6-I-24-HZ
APPLICATION FOR CERTIFICATE OF APPROPRIATENESS

916 Luttrell St. 37917
Fourth and Gill H

Staff Report

File Number: 6-I-24-HZ

- Current front railing

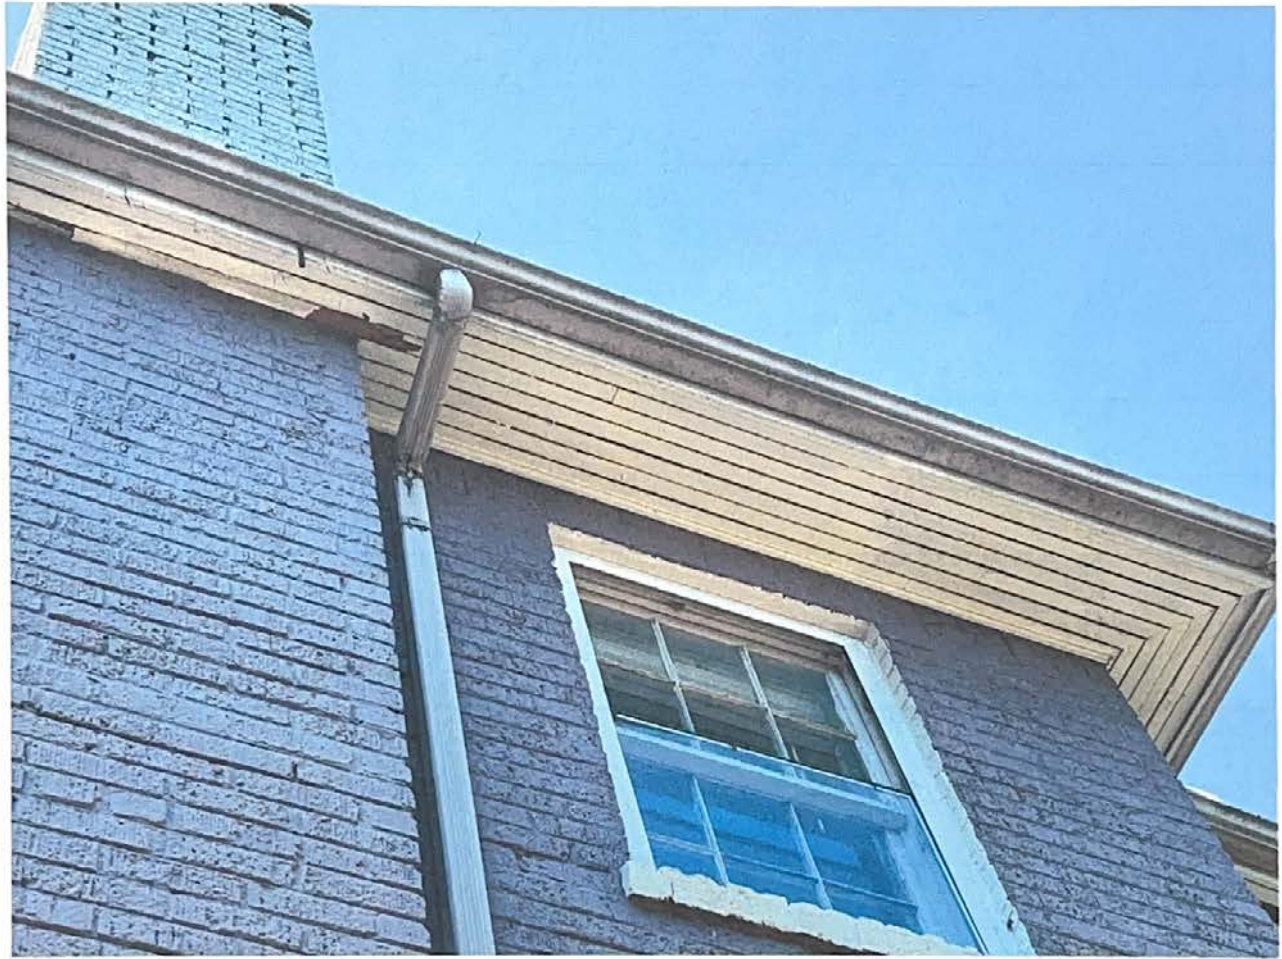
8. While restoring a railing to meet building code requirements can be appropriate within the guidelines, especially when the railing may not be original to the structure, a railing detail drawing should be provided to staff for review. The railing should feature balusters set into the top and bottom rails.

Updates: 916 Luttrell Ave

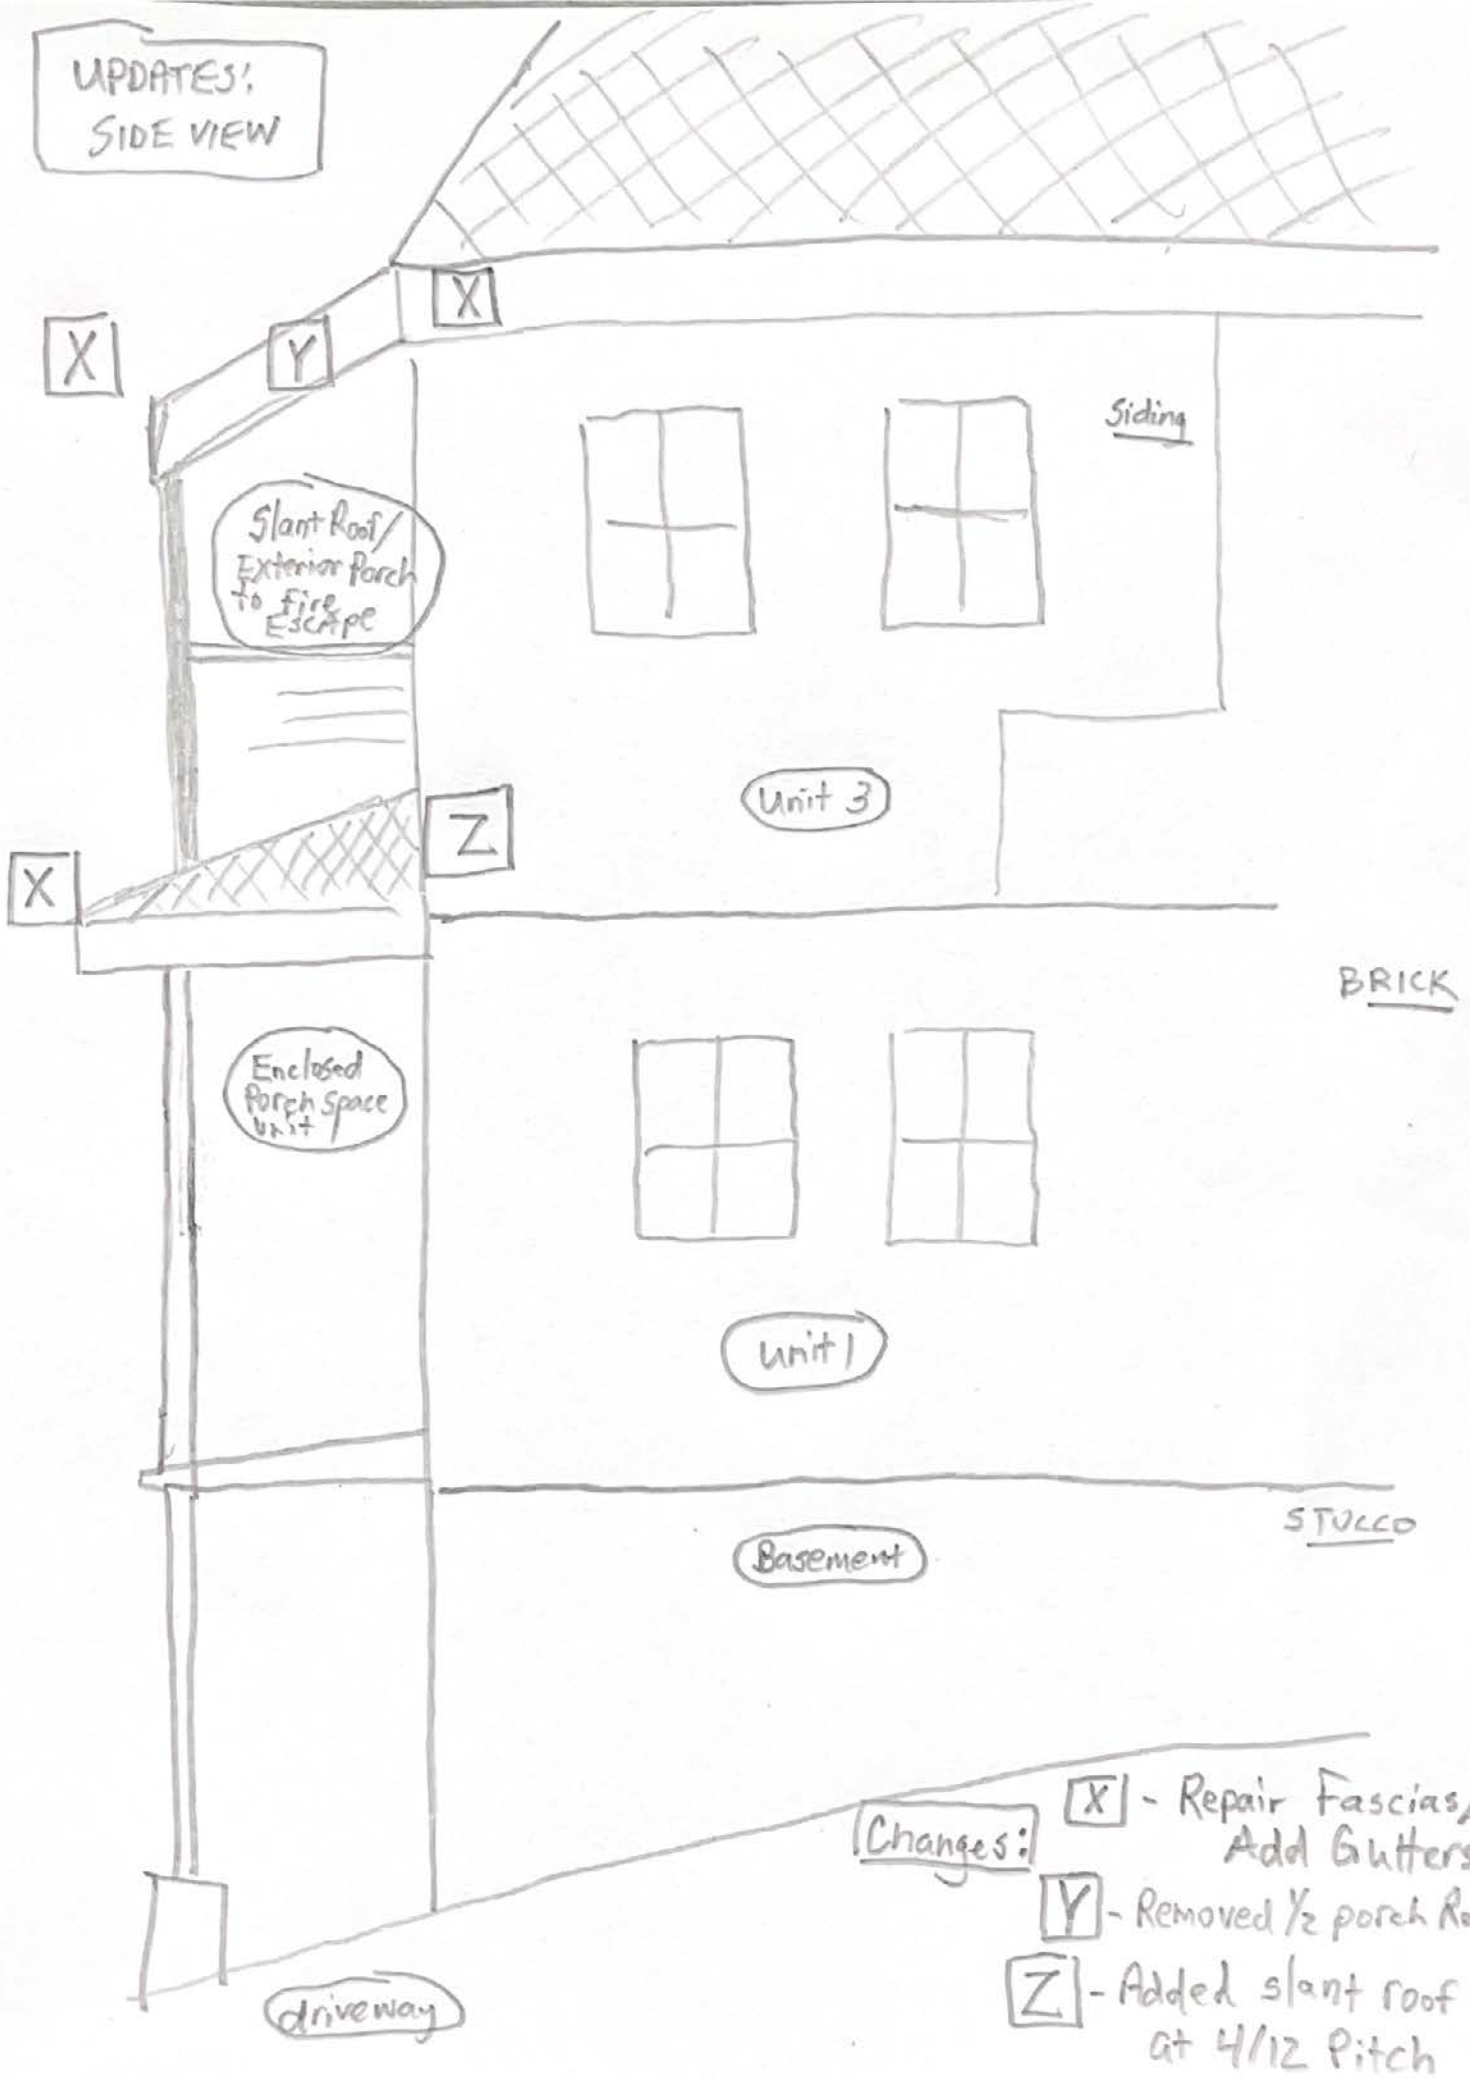
4. As the second-story addition is on the rear and a highly modified elevation of the house, enclosing an additional section of the second story's right side does not detract from the overall character of the house. However, the additional hipped roofline to be added to the right side (labeled as "Z" on the rear elevation drawing and "X" on the side elevation drawing), between the first and second stories, is not compatible with the existing roofline on the left side of the massing and does not appear necessary for the enclosure of the upper story. The half of the existing shed roof with exposed rafter tails has already been removed. The Commission should provide input on the revised rooflines on the various enclosed sections.

5. Fiber cement siding has not typically been approved as a replacement material on original houses, only approved for new additions, new construction, or new secondary structures. Wood lap siding with a 4-5" exposure pattern should be used as the siding material instead of the fiber cement as shown.

6. Vinyl is not an appropriate replacement material for wood within the design guidelines. Wood soffits matching the existing in design and size should be installed instead of vinyl.

7. As the windows proposed for enclosure on the first story are not original elements and not visible from the street, enclosure is appropriate within the design guidelines. The application does not include specifications for proposed new windows. If any new windows are to be installed, final specifications should be submitted to staff for approval and should meet the design guidelines.

Staff recommends approval of the following elements: removal of the existing vinyl siding, repair to the existing fascia and soffits, enclosure of the second-story right side massing, and removal of two windows on the first story. Staff recommends denial of the proposed fiber cement lap siding, with wood lap siding to be substituted and denial of the proposed vinyl soffits, with wood soffits to be installed. Staff recommends a revised roofline drawing for the rear elevation, pending Commission input; a railing detail drawing; and the final window specifications, to be submitted to staff for approval. Additional revisions may be necessary related to building code modifications; items not aligning with design guidelines or the HZC review may require further review by the Commission.
